room2 Homotel: Manchester Piccadilly

Design and Access Statement Addendum (Updated) – July 2024

Document Title	HMP-BA-XX-XX-TRP-A-0004 - Design and Access Statement Addendum (Updated)
Company	Bennetts Associates
Revision	P04
Date	9 th July 2024
Details	Design And Access Statement Addendum updated to address Case Officer comments issued on 13 th June 2024.
Document Number	HMP-BA-XX-XX-TRP-A-0004
Address	Bennetts Associates 38-42 Mosley Street Manchester M2 3AZ

(Above) Diagram showing proposed services strategy in the retained existing building overlaid on the level 3 reflected ceiling plan. The services in each room are concentrated above the new ensuite bathrooms, positioned adjacent the existing chimneys.

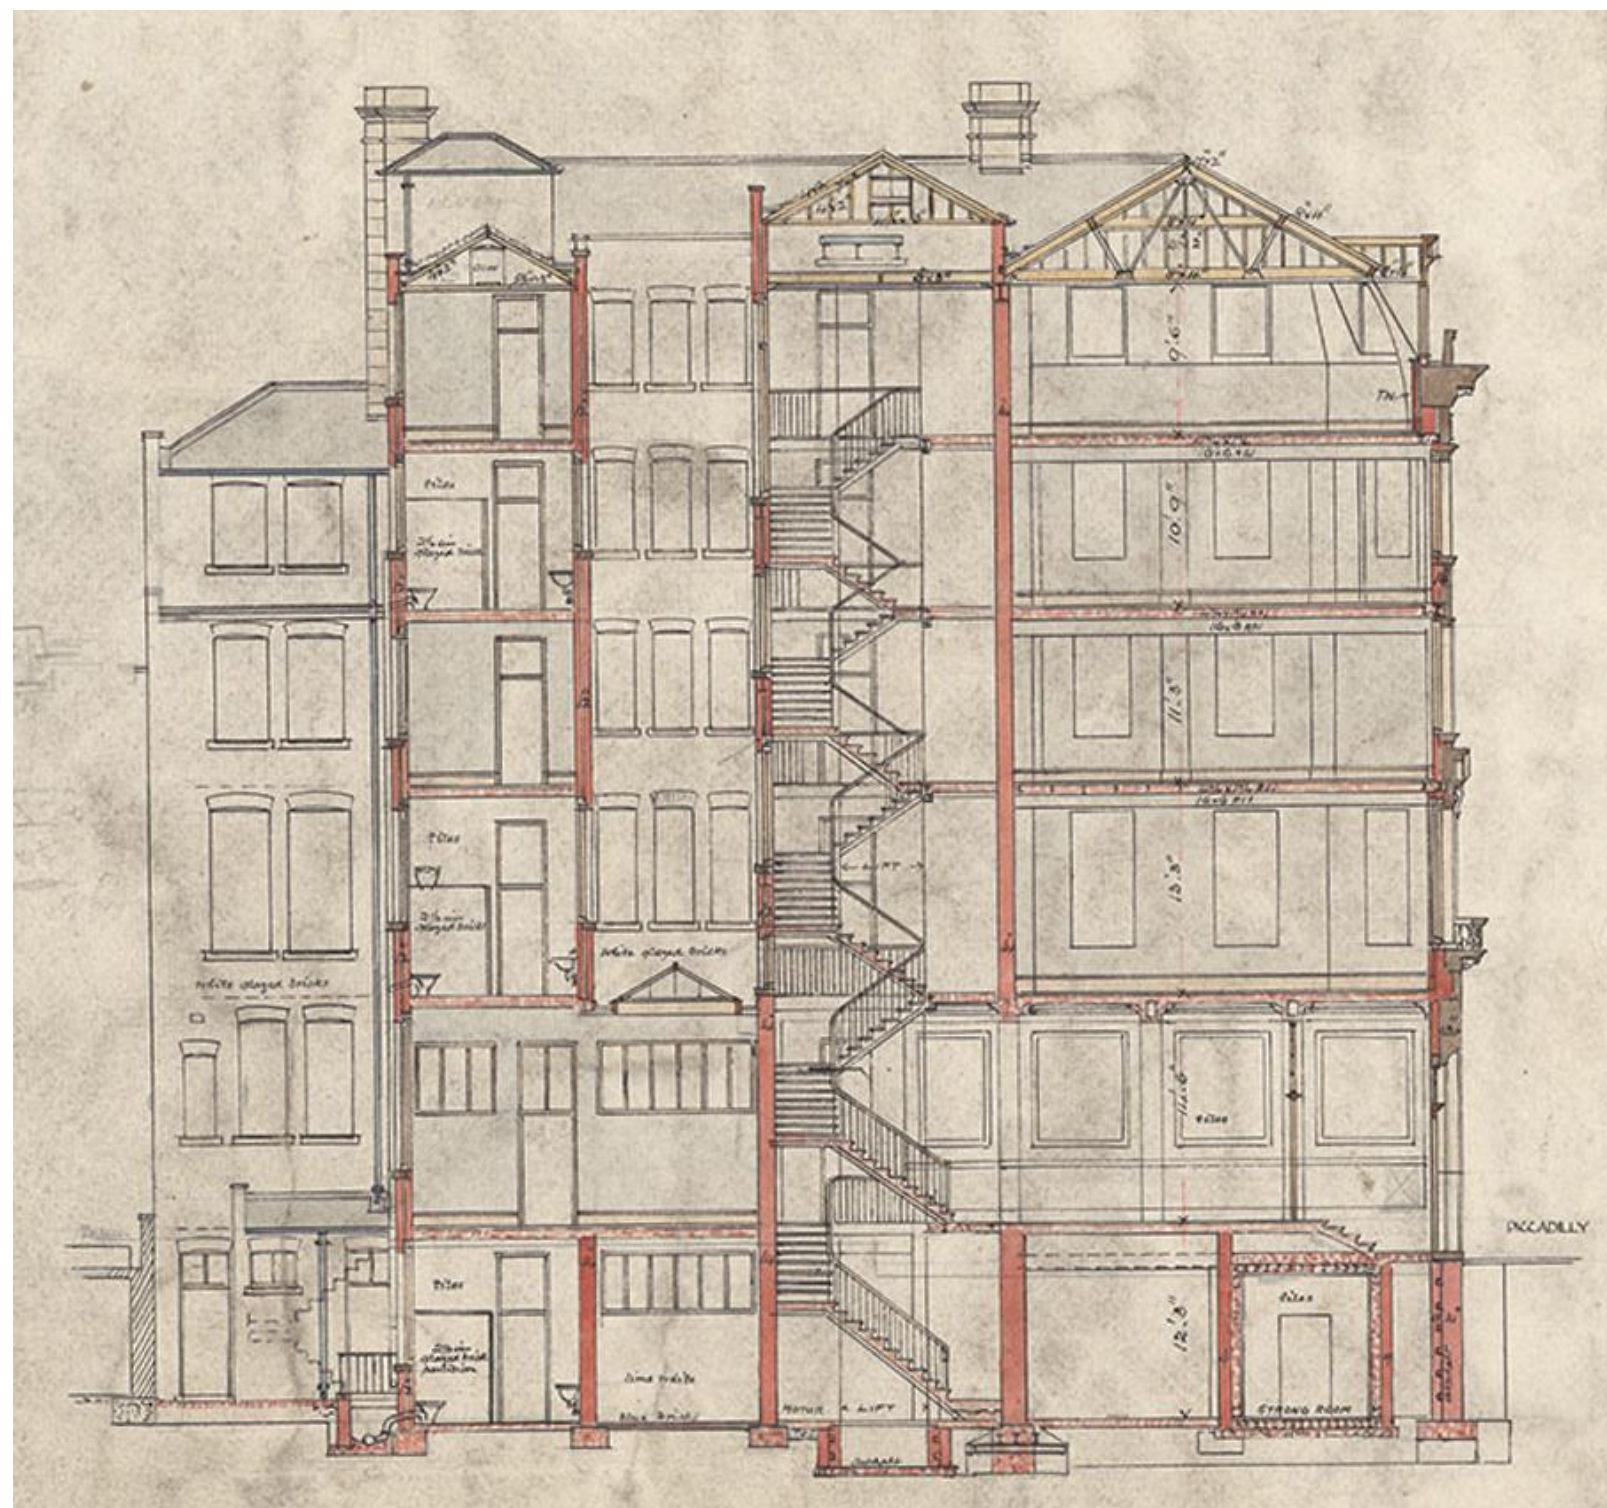
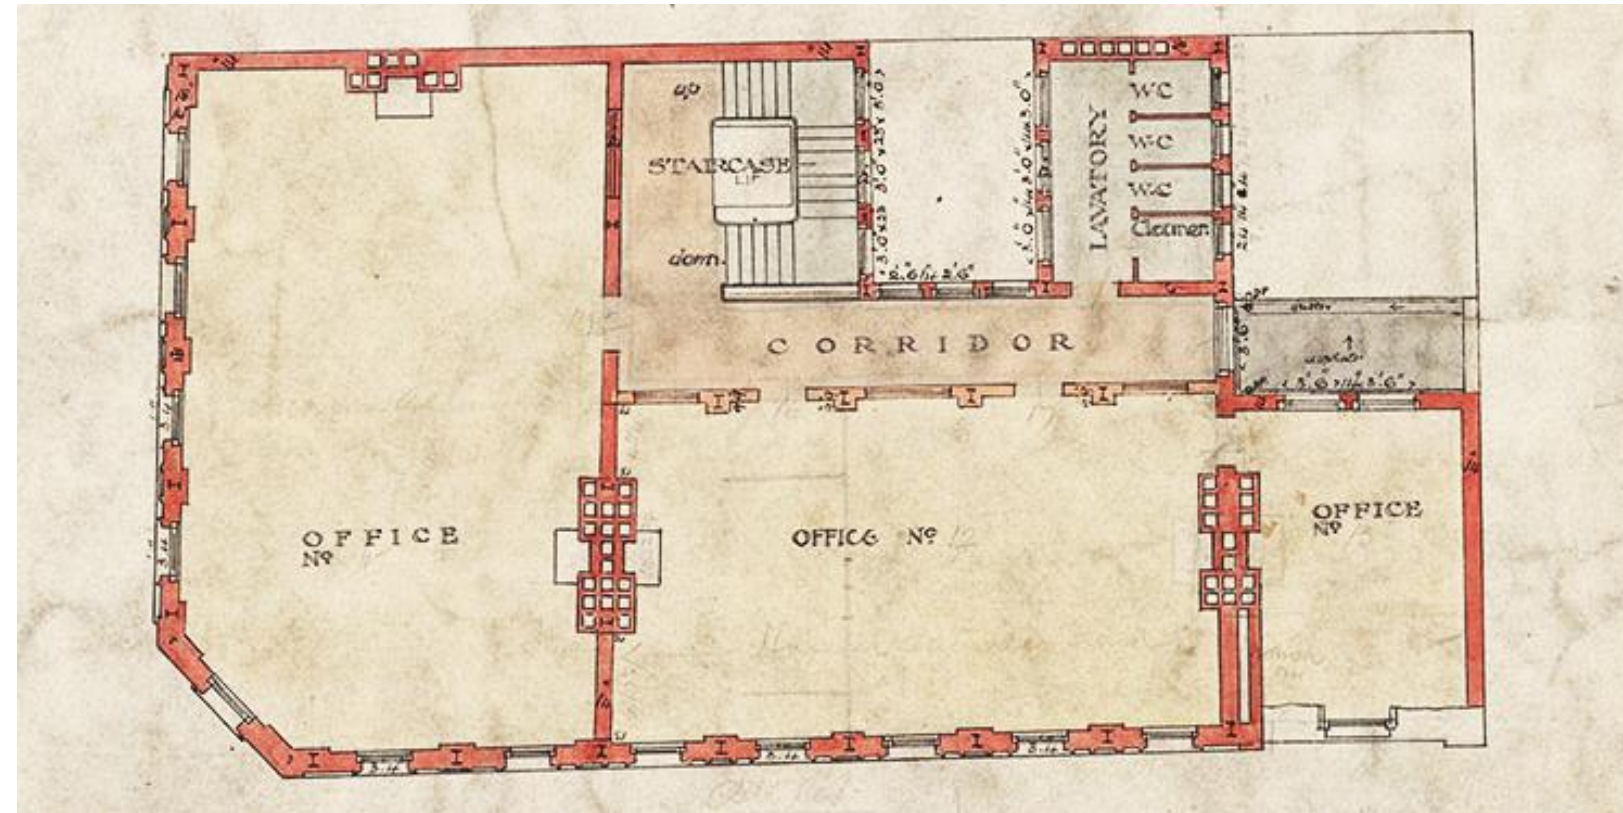
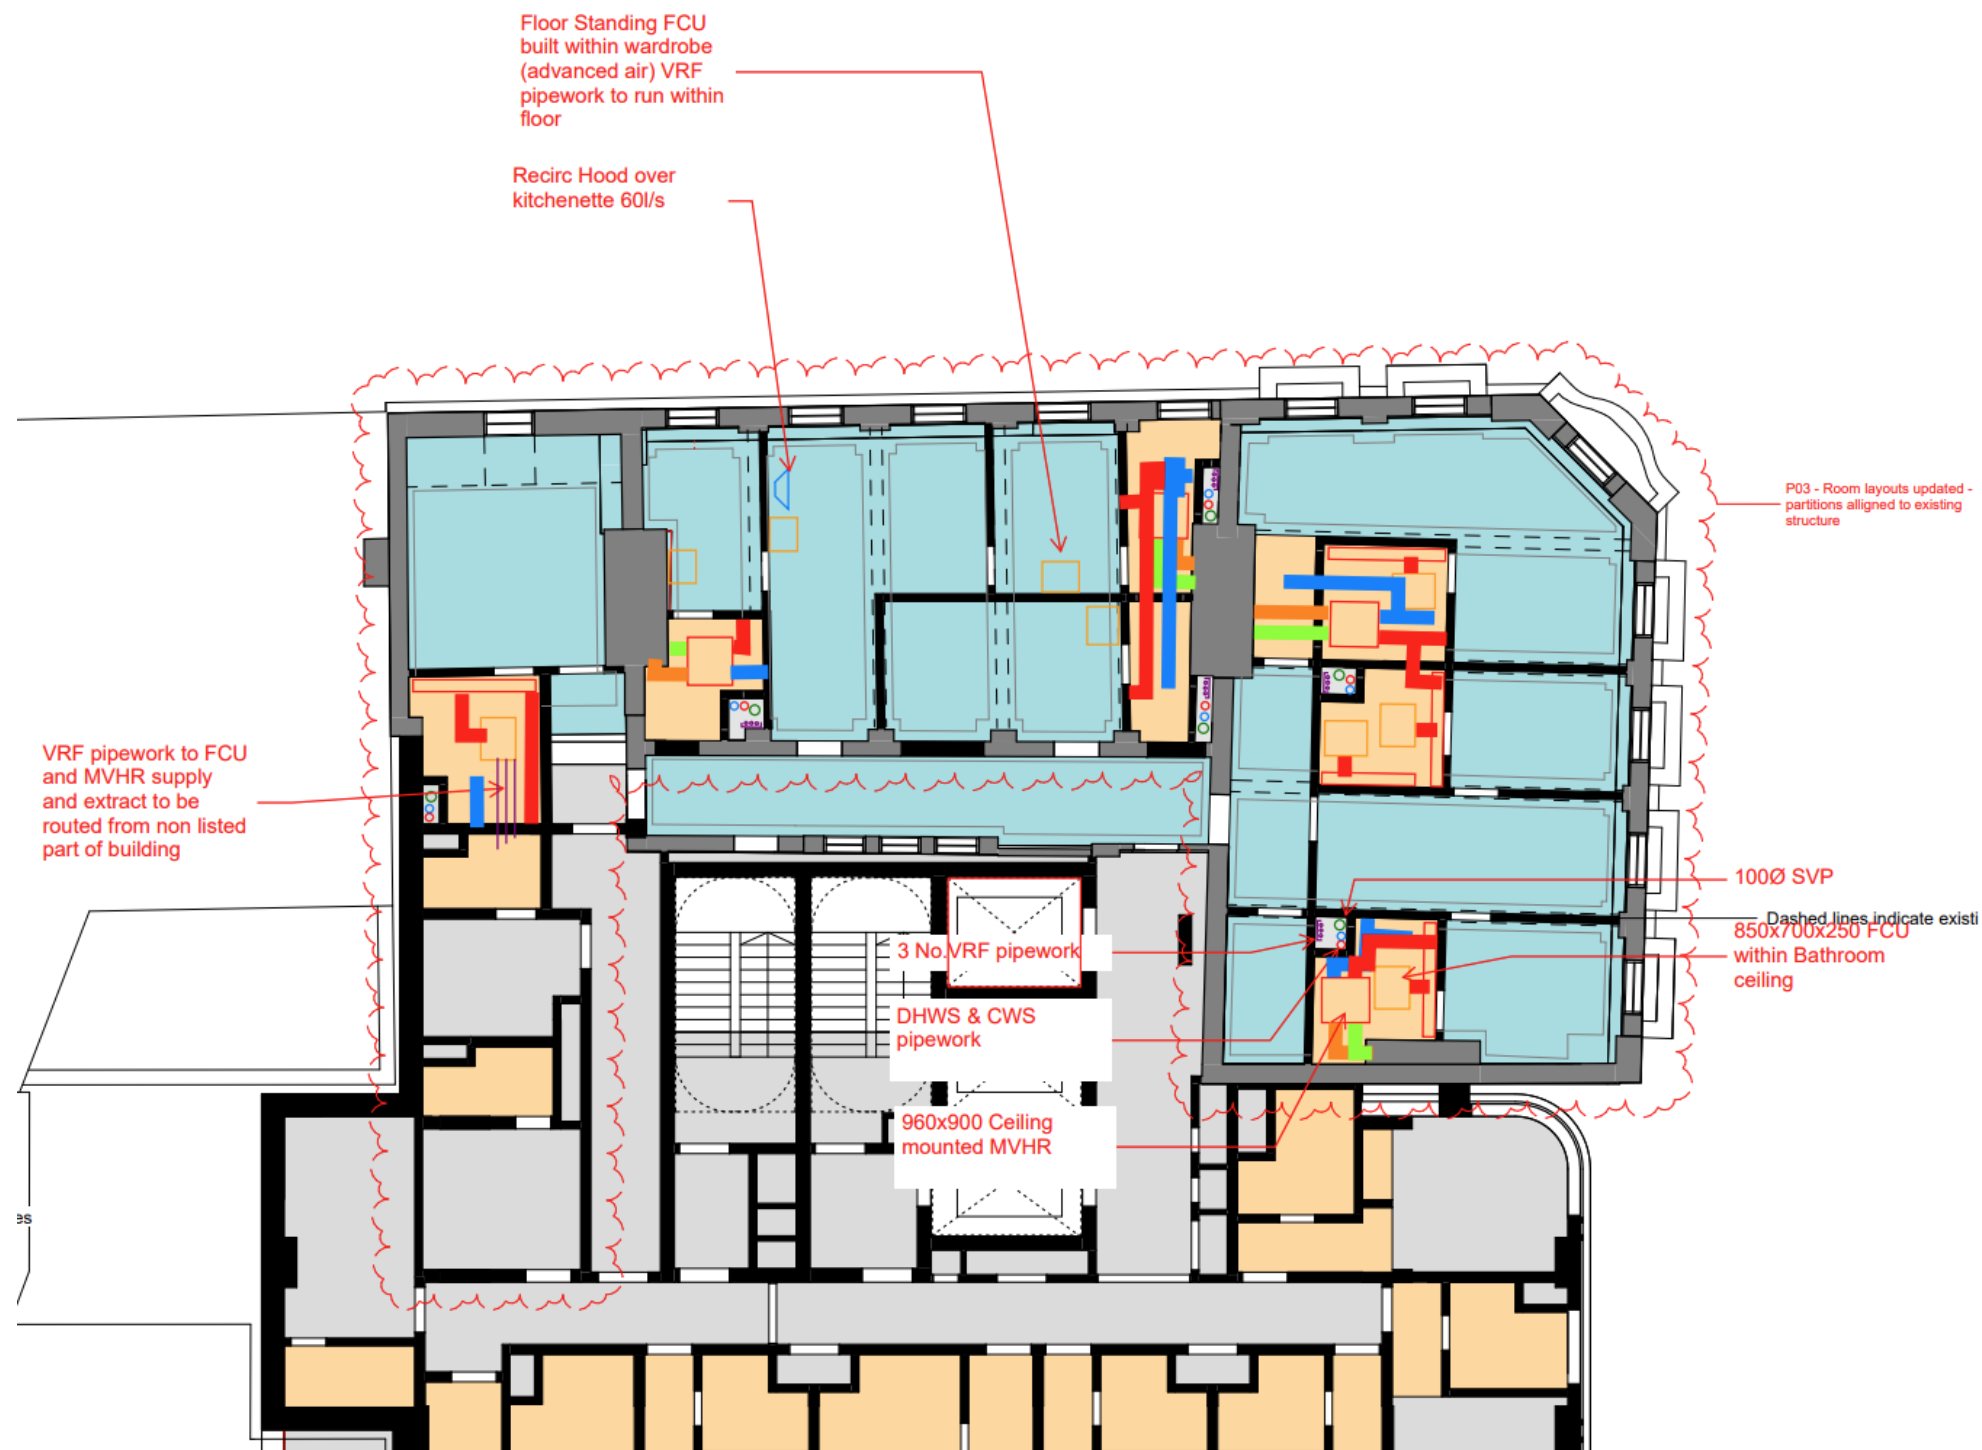
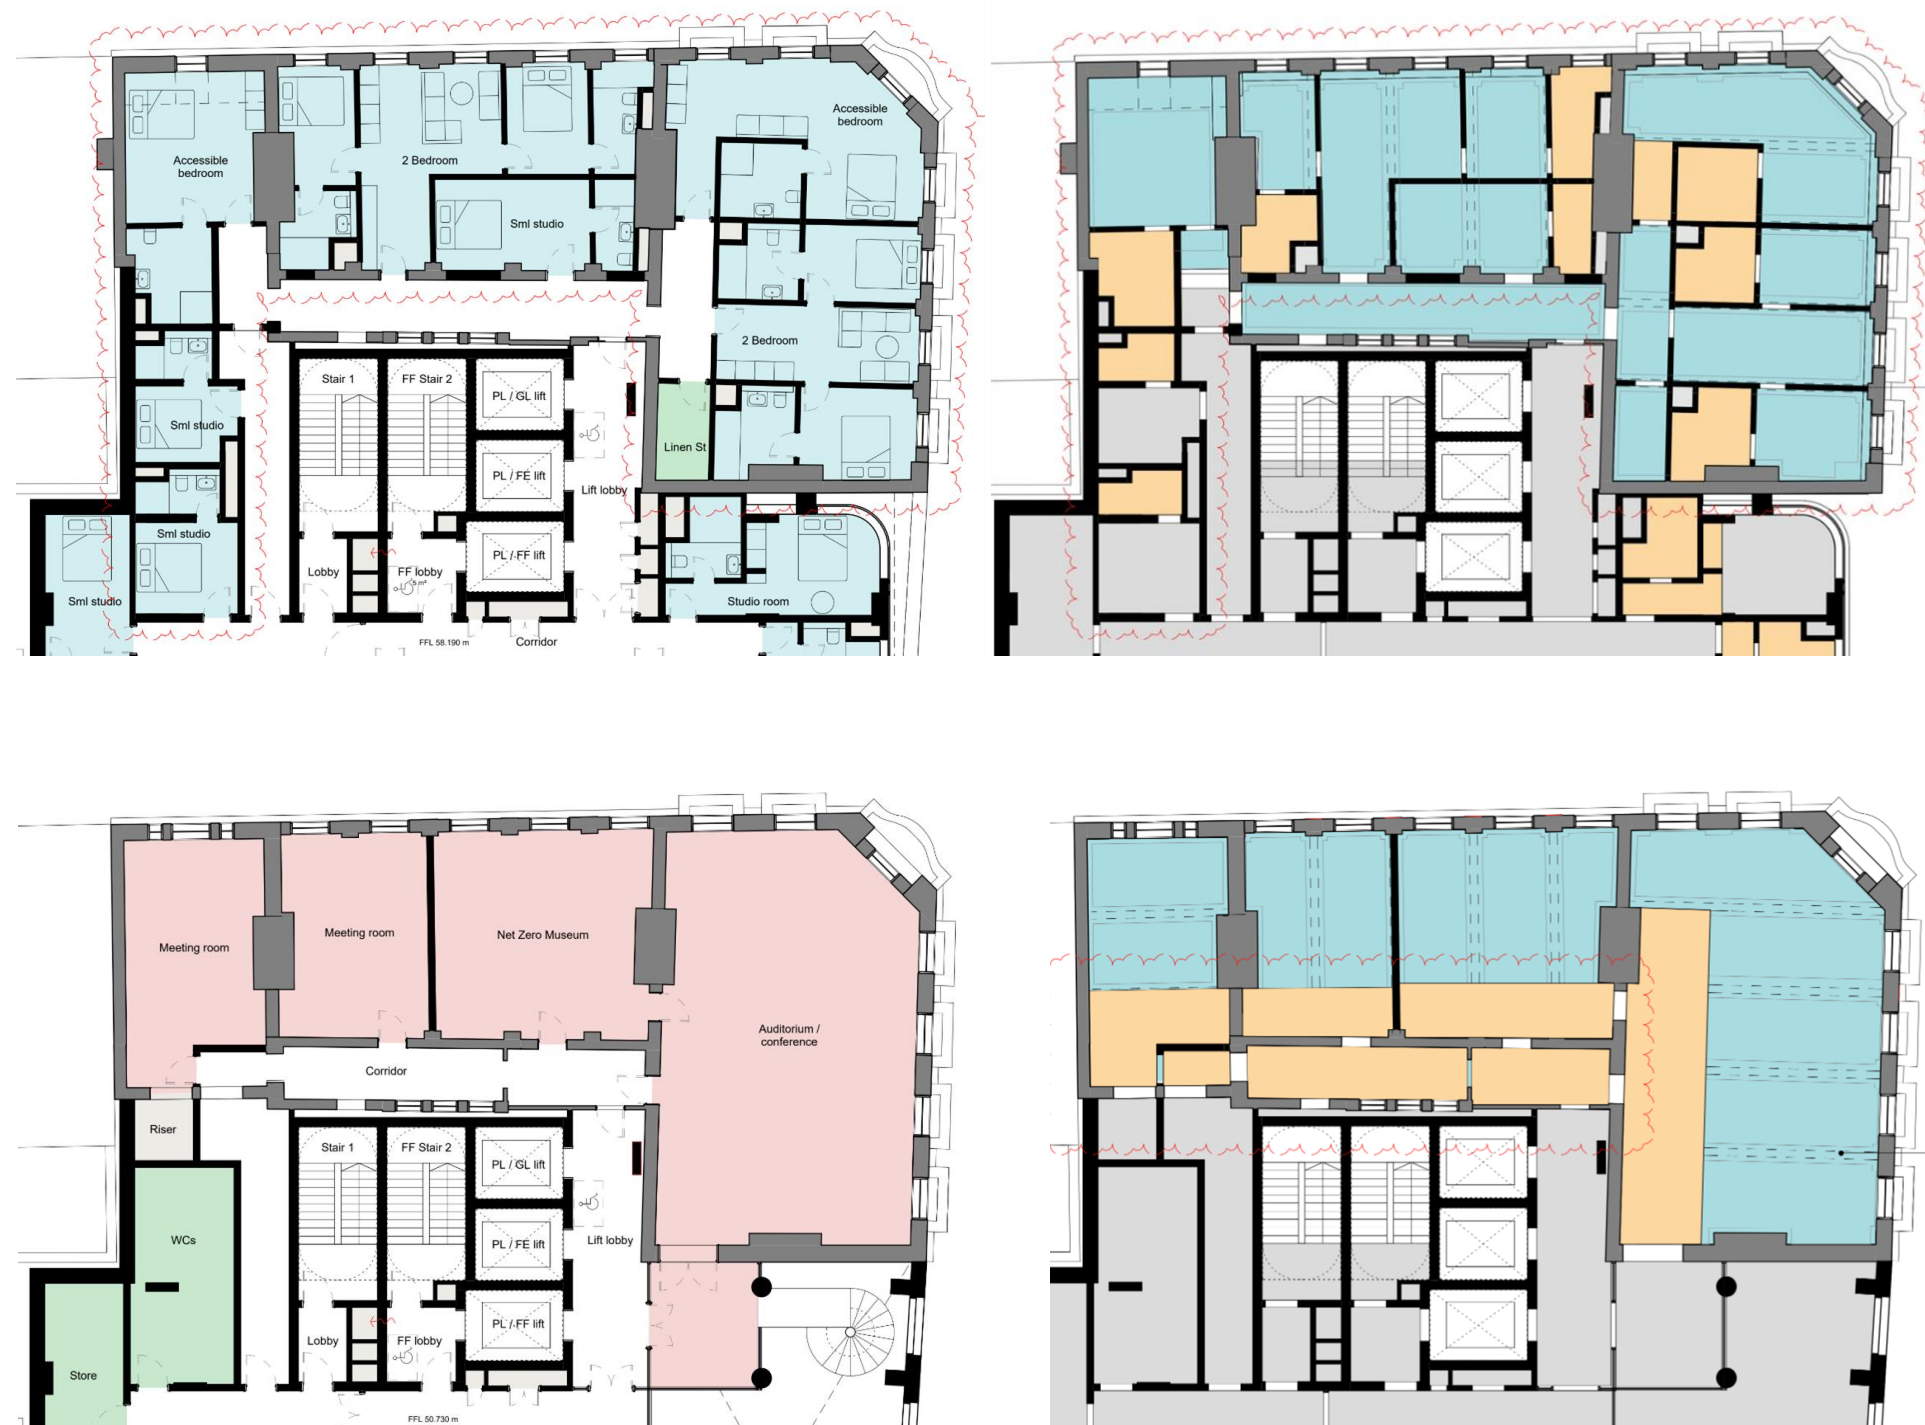
The previous and revised drawings do not show a lot of detail in terms of internal fit out and design and M and E design. These details are required for a full assessment, especially the fit out of the more significant spaces and the impacts of any fixtures and fittings.

The following pages provide further detail on the strategy for proposed building services within the retained existing building. The strategy seeks to minimise the impact on the existing fabric where possible. Given the project stage, the technical details associated with the internal fit-out design and M&E design are not yet fully developed but will be established at a later stage.

In order to provide heating and cooling to the hotel rooms and to work within the confines of the proposed layouts and ceiling plans, it is proposed to maintain the core services above the newly formed ensuite bathrooms which are generally located adjacent to the existing chimney flues.
